Final Report – DRAFT for Review and Comment

Cheyenne Passenger Rail Station Site Selection Study

Railroad Operations, Infrastructure Modifications, and Station Concepts Technical Memorandum

Figure 2 Old Happy Jack Road Passenger Rail Station Concept Plan

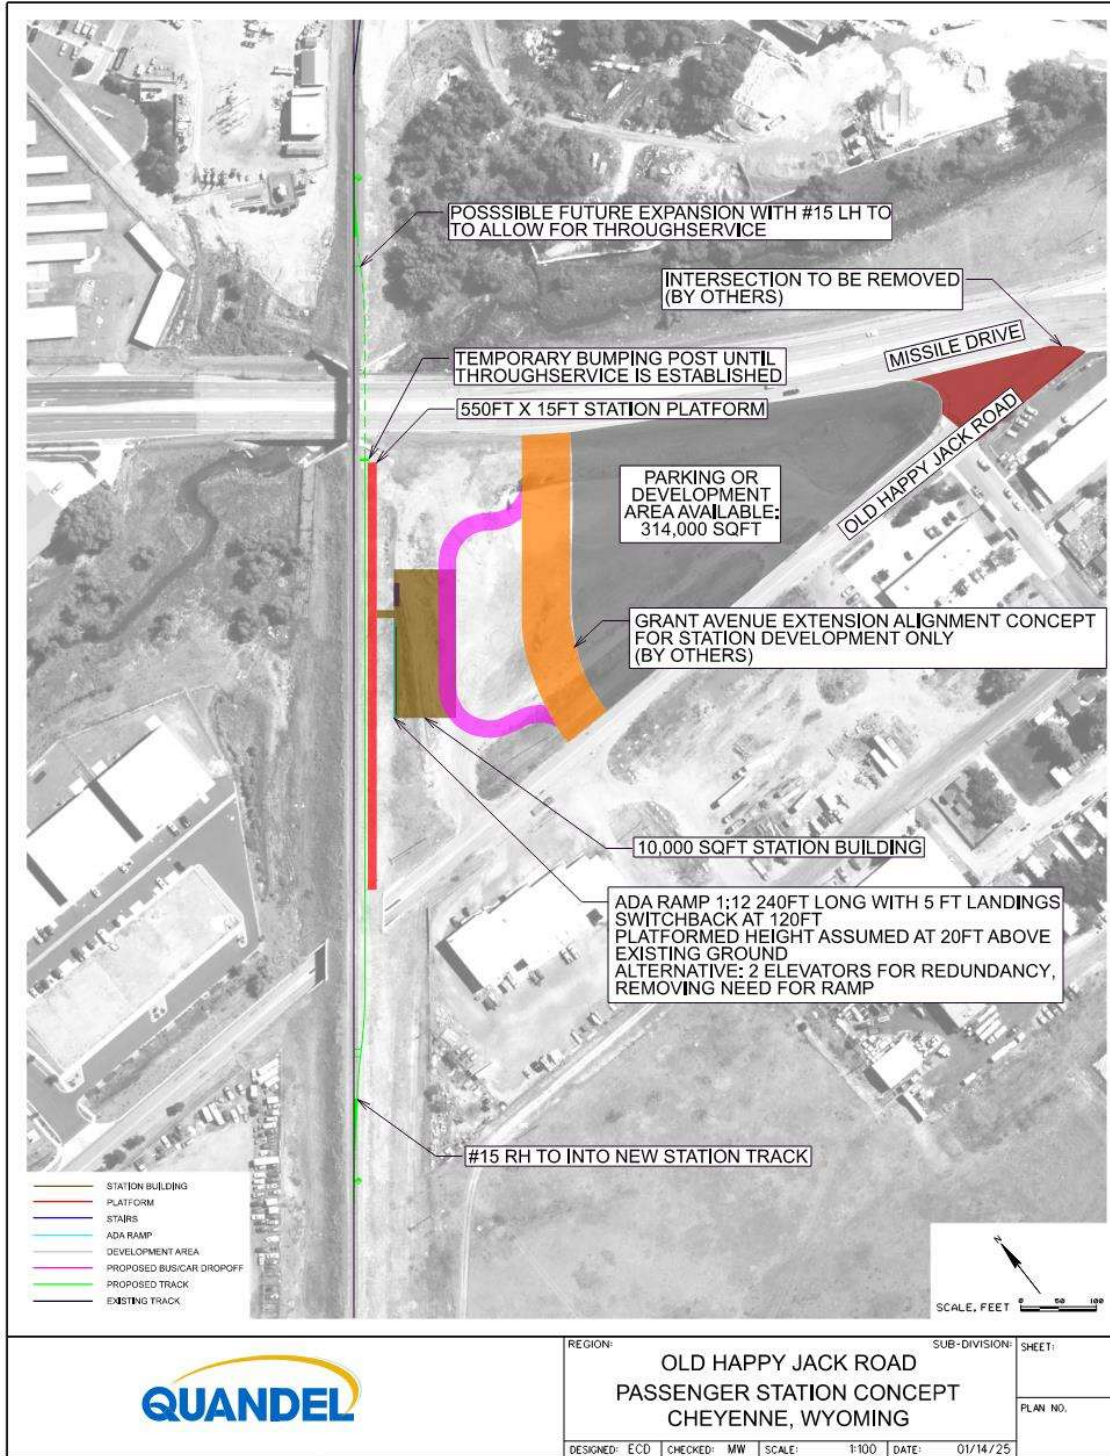
- Charles reviewed the Old Happy Jack Road concept.
 - John agreed with the decision to implement a stub end station track with a bumping post. In general, BNSF prefers options that have the fewest modifications to their mainline track, adding that this option could help streamline BNSF approvals.

Figure 4 Reed Avenue Corridor Passenger Rail Station and Steam Plant Integration Concept Plan

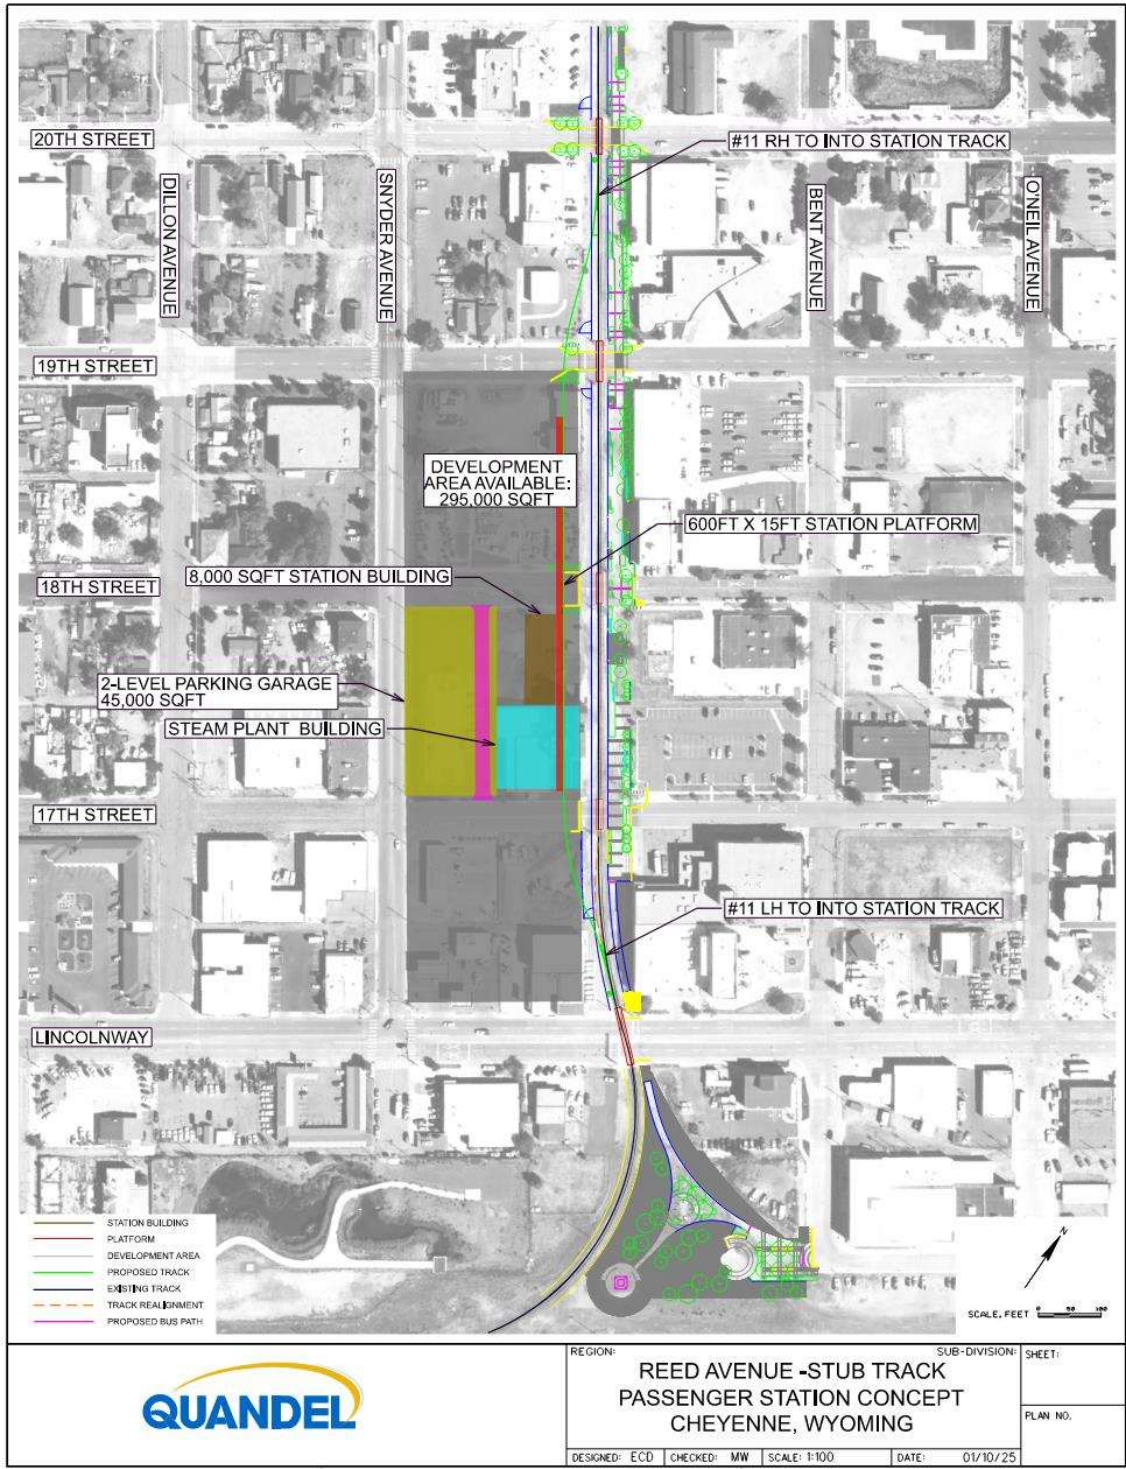
- Charles reviewed the Reed Avenue Steam Plant concept.
 - Amber asked if BNSF had provided input on the track design. Highlighting that a #10 turnout isn't typically used by them.

- Amber expressed concerns with the track geometry, noting that modifications to BNSF's alignment may have a domino effect that could alter the remaining leg of their wye connection to UP's tracks.

- Mary Ann asked that the concept be revised to show #11 turnouts as BNSF does not have the means to maintain #10s.
 - Mary Ann asked if this concept left space for BNSF's access road and fence that are planned on the west side of BNSF's tracks. Charles confirmed the study team accounted for the road; however, it is possibly obstructed near 17th St.

- Charles reviewed the Reed Avenue Steam Plant concept
 - Charles reported that UP expressed concern with the curved track proposed through 19th Street. Adding that this design would require BNSF to order non-standard specialty crossing panels.

- John pointed out the geometric constraints near the Lincolnway at-grade crossing and cautioned that the change from a #10 to #11 would further complicate this alignment.

Figure 5 Reed Avenue Corridor Passenger Rail Station and Stub Track Concept Plan

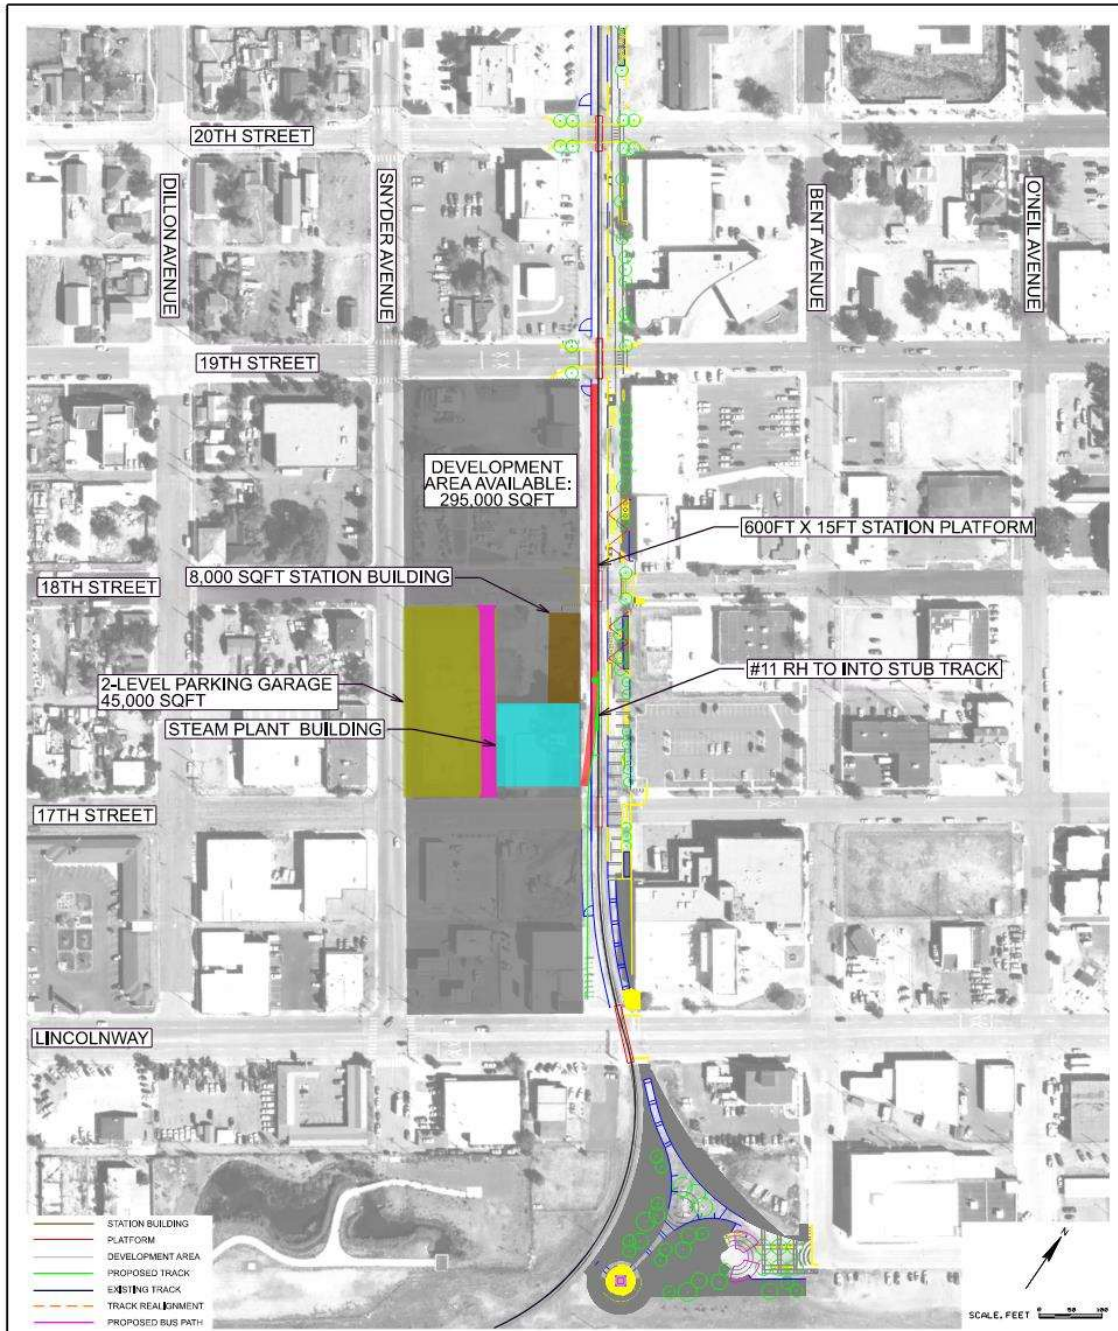
- Charles reviewed the Reed Avenue Stub-Track concept.
 - Mark confirmed that the plan employs 15' track centers.
 - Amber noted the right-of-way width is set by ordinance.

- Mark explained that this plan would use the BNSF's existing track to board an alight customers, and the stub-track would allow trains to clear the mainline while not in service.

- Amber explained that this plan is problematic because it has potential to hinder the rock trains. These trains are unscheduled and needed for critical railroad repairs.
